Access Compliance Report

Public Rights-of-Way

(Curb Ramps)

Intersection ID: 25832	Main Street: STRAWBERRY_LN	Cross Street: FAIRWAY_DOWNS_CT	Location:	NE
ADA ID: F4A59E5C32ED	Ramp Type: PerpDiag	Initial Pass/Fail: Fail	Overall Compliance: No	Severity Score: 25
Codes/Mitigation Info/Possible Solution		Field Measurements/Component Compliance

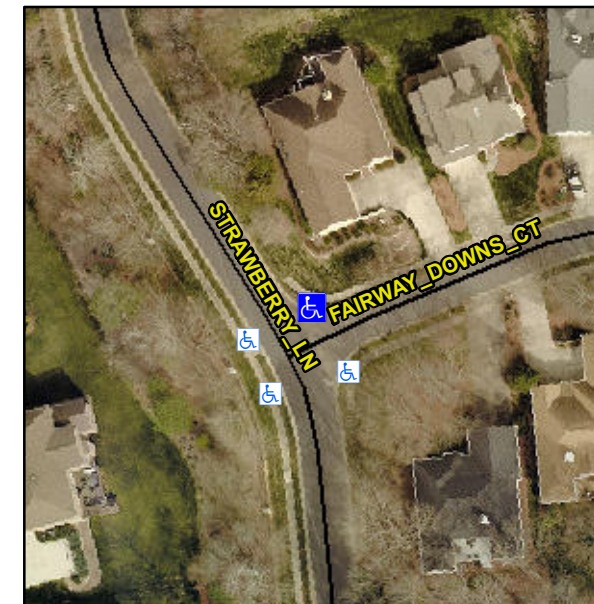
Possible Solutions:

Remove & Replace Curb Ramp With Two New Directional Ramps or Equivalent.

PROW/ADA:

R304.2.2

Compliance	Description	Data	Compliance	Description	Data
N/A	Ramp Length (in)	47.0	No	Ramp Slope (%)	12.0
Yes	Ramp Width (in)	48.0	Yes	Ramp XSlope (%)	0.3
N/A	Flare Type LT	N/A	N/A	Flare Type RT	N/A
N/A	Flare Slope LT (%)	N/A	N/A	Flare Slope RT (%)	N/A
N/A	Flare Traversable LT?	N/A	N/A	Flare Traversable RT?	N/A
N/A	Landing Length (in)	N/A	N/A	DWS Provided?	N/A
N/A	Landing Width (in)	N/A	N/A	DWS Contrast?	N/A
N/A	Landing Slope (%)	N/A	N/A	DWS Length (in)	N/A
N/A	Landing X Slope (%)	N/A	N/A	DWS Full Width?	N/A
N/A	Landing Curb? (Y/N)	N/A	N/A	DWS Offset (in)	N/A
N/A	Shared Landing?	N/A			
N/A	Gutter Ponding?	N/A	N/A	Gutter Slope (%)	N/A
N/A	Gutter Lip Ht (in)	N/A	N/A	Gutter X Slope (%)	N/A
N/A	Painted X Walk1?	No	N/A	Painted X Walk2?	No
	X Walk 1 Direction	To SW		X Walk 2 Direction	To SE
N/A	X Walk 1 Width (in)	N/A	N/A	X Walk 2 Width (in)	N/A
	X Walk 1 Slope (%)	0.0		X Walk 2 Slope (%)	0.2
	X Walk 1 X Slope (%)	0.7		X Walk 2 X Slope (%)	0.2
